# **Knight Piésold Ltd.**

YOUR REFERENCE  
OUR REFERENCE  
NUMBER  
10162/9.01  
8/2028  
August 7, 1998

## **Re: Wood Debris Along Upstream Face of Tailings Embankment**

The attached Figure 1 illustrates the location and extent of the wood debris that has accumulated along the upstream face of the tailings dam.

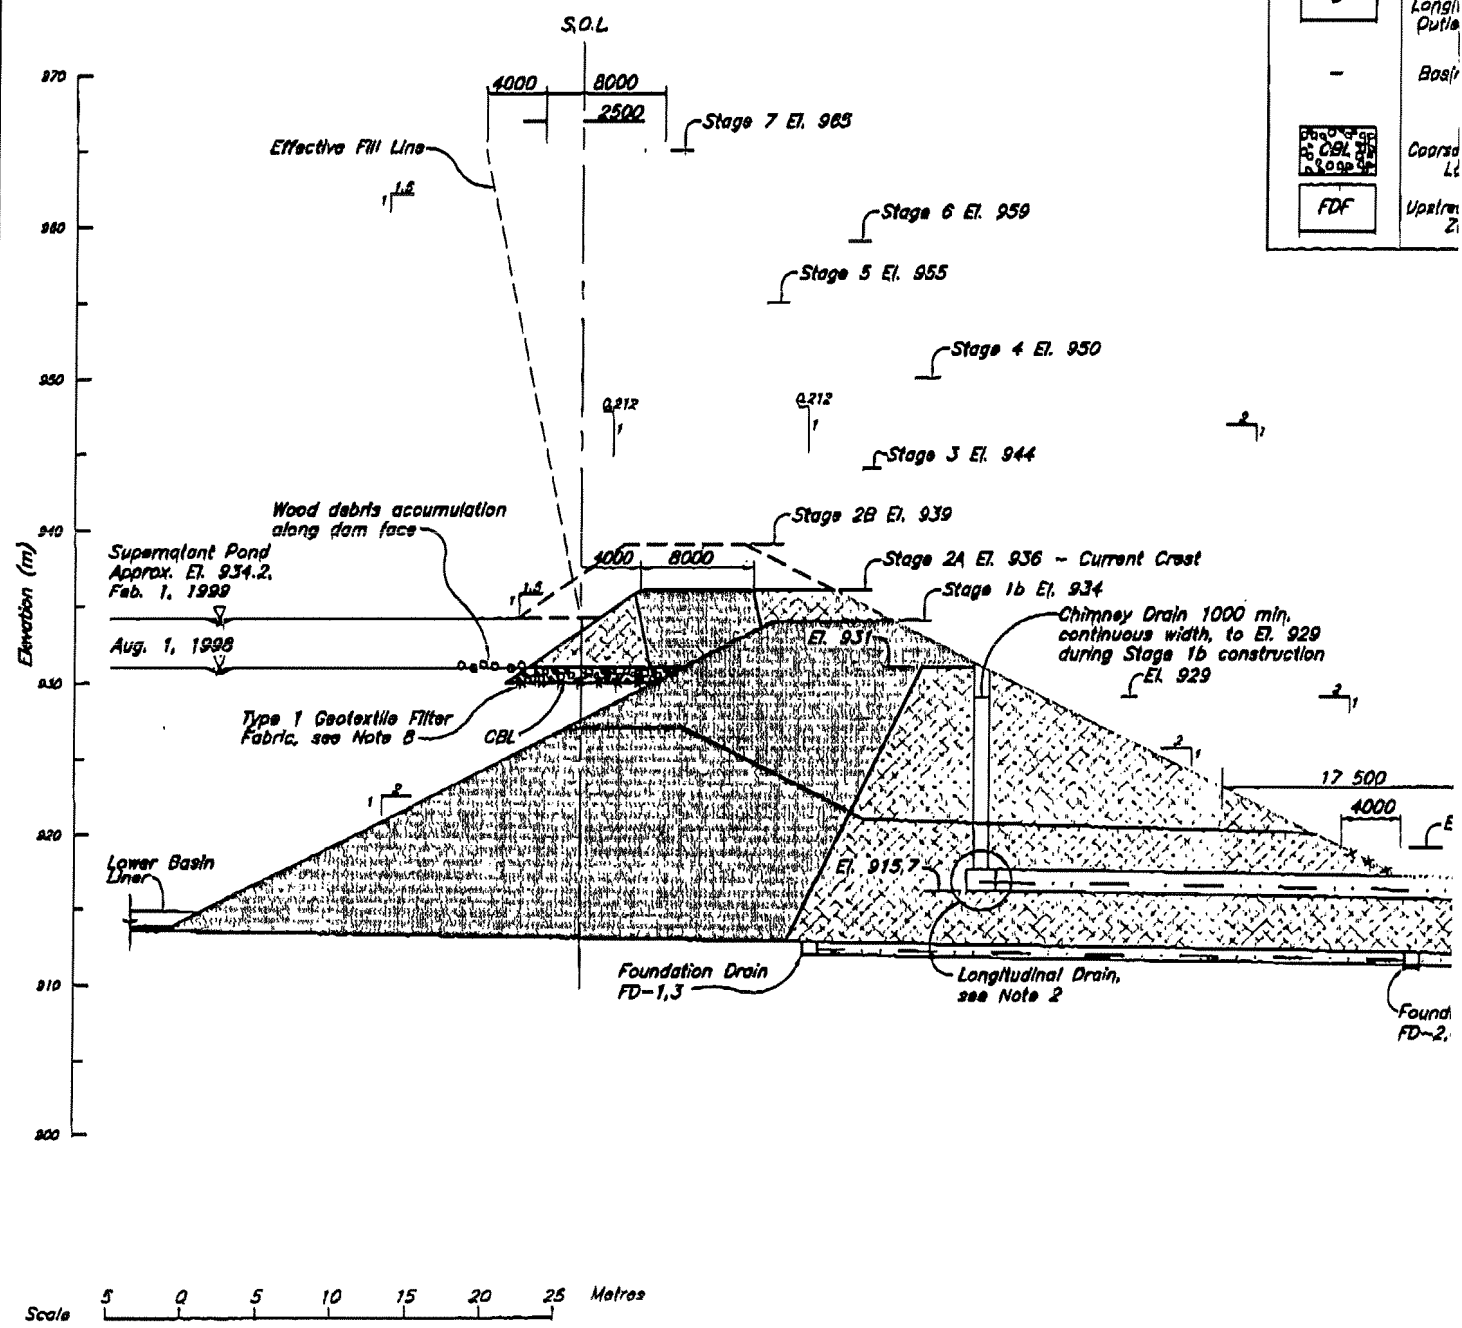
It is our understanding that the Ministry of Energy and Mines have requested removal of floating wood debris which has accumulated along the upstream face of the dam. Knight Piésold have also provided a similar recommendation in our Annual Report. However, we understand that MPMC attempts at removing the wood have been unsuccessful to date and that a contractor is currently on site to continue these efforts. We also understand that MPMC are concerned about the following:

In general, it is good practice to keep wood debris away from the dam face and avoid burial in the tailings beach where primary rotting wood debris could result in settlement at a future date, and/or create a higher permeability zone. However, we have evaluated the potential adverse implications in more detail and compared these

with the costs for removal of the wood debris. This evaluation suggests that it will be possible to bury the wood debris in the tailings beaches during tailings deposition without incurring additional risk of adverse impacts. The upstream toe drain system has not yet been installed, and therefore, the long term phreatic surface in the impoundment will be maintained above the level of the wood debris. The wood debris would not be susceptible to decay during operations. Also, decomposition of the wood debris (if were to occur) would not result in excessive differential settlement which could adversely affect the integrity of the dam structure.

We believe that MPMC should be concentrating efforts on spigotting and/or cycloning to form a continuous tailings beach along the upstream face of the dam rather than cause further delays with wood removal activities. However, appropriate precautions should be included to ensure that this problem does not re-occur. We recommend that a log boom be constructed using the larger logs that are currently situated along the dam face.
